UNITED STATES PATENT AND TRADEMARK OFFICE

APPLICATION NO.	FILING DATE	FIRST NAMED INVENTOR	ATTORNEY DOCKET NO.	CONFIRMATION NO.
10/812,159	03/29/2004	Richard A. Blanchard	GS 124 D1	2962

Office Action Summary

DETAILED OFFICE ACTION

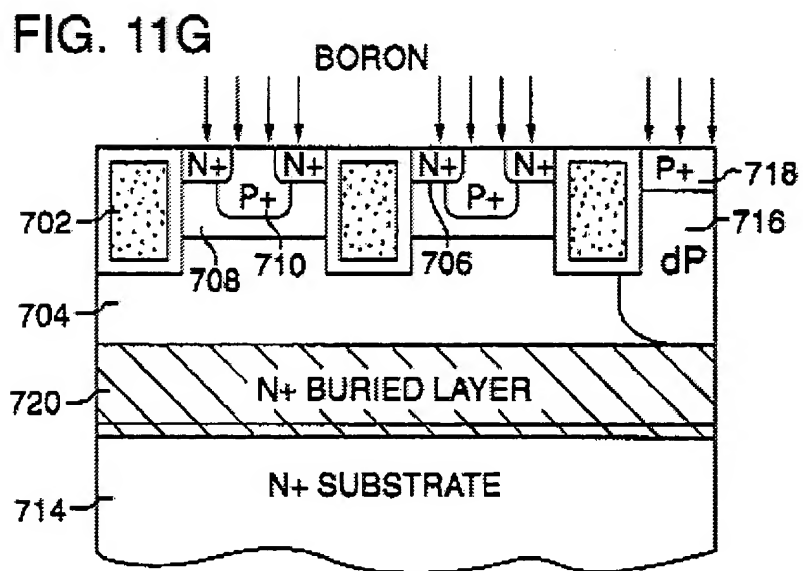
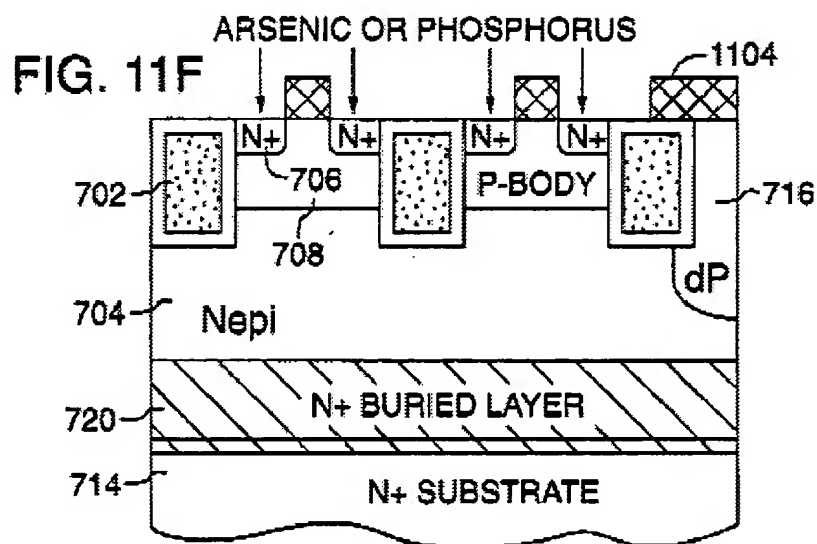
Williams (the abstract, fig 11F, fig 11G, fig 5C, fig 5D) discloses a double diffused field effect transistor made in accordance with the method comprising: providing a substrate of a first conductivity type (fig 11G layer 714); introducing at least one dopant species of the first conductivity type into a surface of the substrate so that the substrate has a non-uniform doping profile; forming an epitaxial layer of the first conductivity type over the substrate (fig 11F layer 704), forming one or more body regions of a second conductivity type within the epitaxial layer; forming a plurality of source regions (fig 11F region 706) of the first conductivity type within the body regions; and forming a gate region (fig 11F region 702) adjacent to the one or more body regions.

FIG. 4

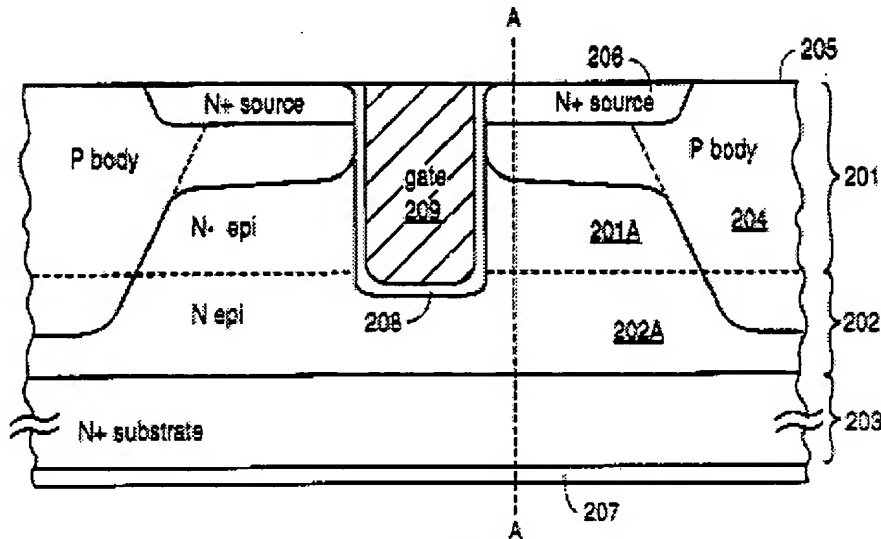
Similarly, Hsieh et al. (the abstract, fig 4, layer 203, layer 202,layer 204,layer 206)

Disclose the same invention

Similarly, Hsieh et al. (fig 4, column 1 line 57-58) disclose the same invention

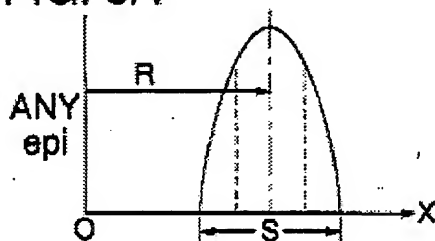
Williams (the abstract, fig 11D, fig 11F) discloses a double diffused field effect transistor made in accordance with the method wherein the step of forming the gate region includes the steps of: forming a plurality of trenches within the epitaxial layer; forming a first insulating layer that lines the trenches, and forming a polysilicon conductor within the trenches and overlying the first insulating layer.

FIG. 5A**FIG. 5B****REGARDING CLAIM 5**

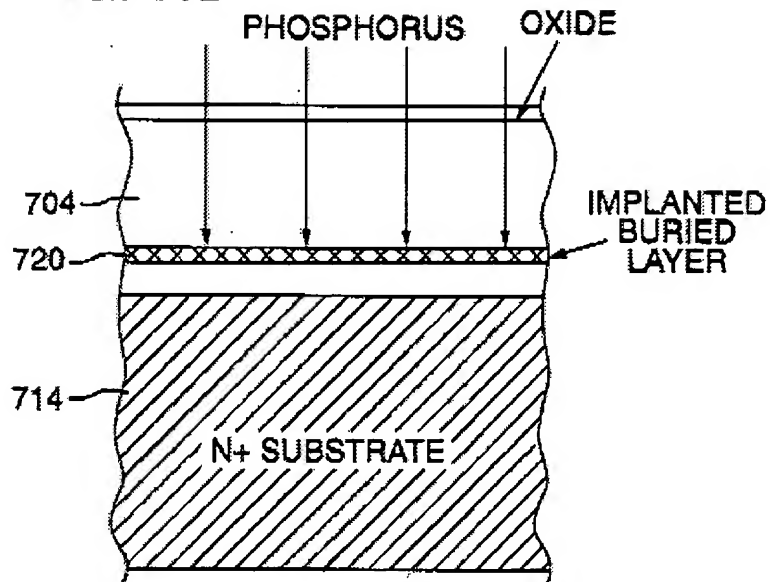
Williams (the abstract, fig 5A, fig 5B, fig 11D, fig 11F) discloses a double diffused field effect transistor, comprising: a substrate of a first conductivity type; at least one dopant species of the first conductivity type incorporated into a surface of the substrate so that the substrate has a non-uniform doping profile, the non-uniform doping profile having a dopant concentration that is greatest at a given depth below a surface layer of the substrate and which decreases with increasing distance away from the given depth (fig 5A) ; and wherein said gate region includes a plurality of trenches located within said epitaxial layer; a first insulating layer (fig 11D layer 1102) that lines said trenches, and a polysilicon conductor (fig 11D layer 702) located within said trenches and overlying the first insulating layer.
